Mr. Brian Moore
49 Farm Road
Sherborn, MA
Re: Farm Road 40B, Sherborn, MA

At your request I have reviewed the most recent reports and groundwater modeling results prepared by Creative Land and Water Engineering (CLWE) associated with the proposed 40B development at Farm Road, Sherborn, MA. The proposed project is located adjacent to your property and is hydrologically upgradient from your property. I understand that you and several of your neighbors have private drinking water supply wells on your properties. I also understand that your property contains a jurisdictional wetland projected under the Massachusetts Wetlands Protection Regulations.

Table 3.1 - SAS Soil Testing Summary

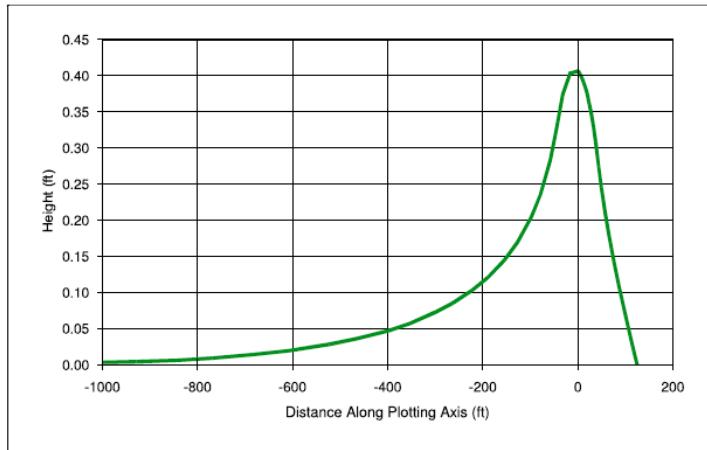
In fact, the actual test pit data provided by CLWE shows only a saturated thickness of 3.96 feet. Table 3.1 from the Hydrogeologic Evaluations Report (shown below) summarizes the test pit data and shows the estimated seasonal high groundwater (ESHGW) or water table and the bottom of hole (test pit) – the difference is the measured saturated thickness. Although I agree that there is likely to be additional saturated thickness beneath the test pit elevations, the selection of 14.5 feet or 20 feet (later in the report) as a saturated thickness is not supported by the data.

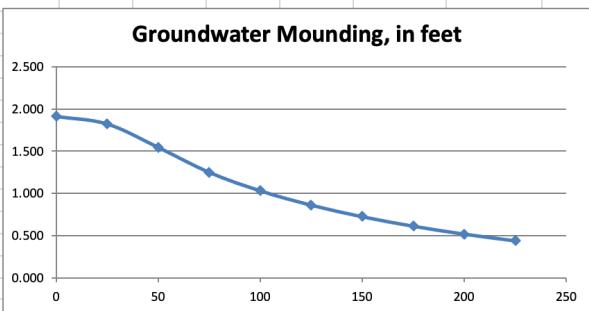
I have re-run the groundwater mounding model (Hantush) using more conservative values for hydraulic conductivity and saturated thickness but maintaining other inputs to the model in accordance with CLWE’s estimates. Because there are no available in-situ permeability tests (as recommended by MADEP) I selected the most conservative hydraulic conductivity values presented in CLWE’s Table S3 (shown below). I assumed a saturated thickness of 8 feet (twice the value that CLWE measured).

The results of the modelling shows significant groundwater mounding directly underneath the wastewater disposal field at 1.9 feet and 0.7 feet at the wetland. The results at the stormwater infiltration facility indicate groundwater mounding of 8.5 beneath the system and 2.0 feet at the wetland boundary. To my knowledge CLWE has not reported on groundwater mounding at the stormwater infiltration facility.

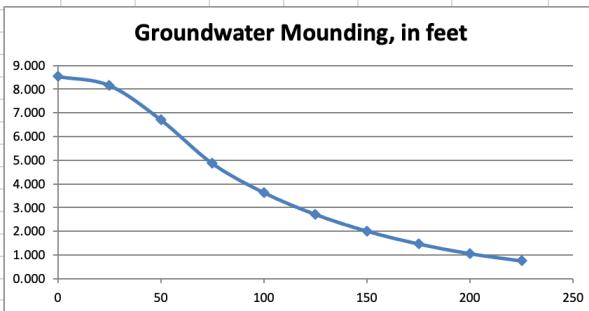
My analyses indicate that the groundwater mounding associated with the stormwater and wastewater facilities will overlap causing cumulative impacts. They need to be evaluated together. The stormwater mounding will redirect (or push) the wastewater effluent further south in the direction of the private wells on neighboring properties. The CLWE analysis does not provide groundwater mounding for the stormwater facility and clearly does not address the cumulative impacts between the stormwater and wastewater facilities.

Figure 4 – Areas of Impact

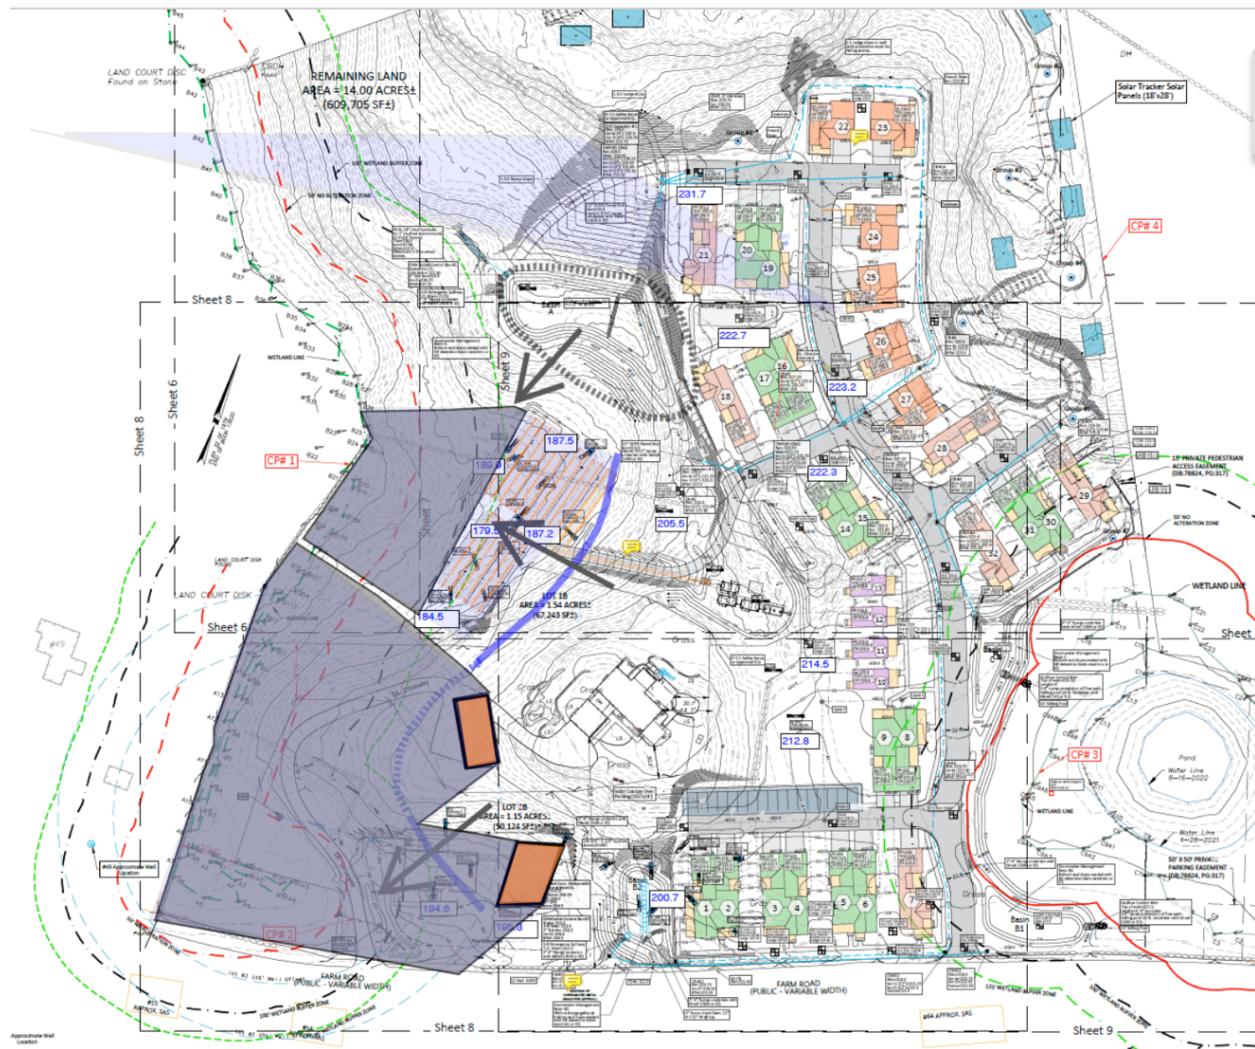
To determine groundwater flow directions on the subject property I plotted existing groundwater elevations provided by the applicant's consultant, Creative Land and Water Development. A series of test pits shown on the site plans provide estimated seasonal high groundwater (ESHGW) elevations. Utilizing this data I constructed a water table map (highlighting the 195-foot contour) which indicates groundwater flow in a westerly direction.

Based upon these groundwater flow directions I delineated two Areas of Impact (AOI). The northerly AOI is downgradient of the proposed 40B development septic system and the southerly AOI is downgradient of septic systems on two adjacent lots. The locations of the septic systems are shown on a basemap prepared by Creative Land Development dated September 28, 2023 (see figure 4).

This analysis indicates that the proposed wastewater discharges will result in nitrate-nitrogen concentrations in excess of state and federal drinking water standard of 10 mg/liter for nitrate-nitrogen at the property boundary of your land. There is an additional drinking water well on the adjacent lots within the Area of Impact that will also be degraded by the wastewater discharges.

This analysis is provided as a preliminary/conceptual assessment. A more detailed analysis of these impacts is required by the Sherborn Board of Health Regulations and should be provided by the applicant. This assessment should be updated and revised to include the cumulative groundwater mounding impacts associated with the proposed stormwater and wastewater disposal systems. This will redirect the wastewater plume associated with the 40B septic system further south. A more detailed analysis of the cumulative impacts is required.
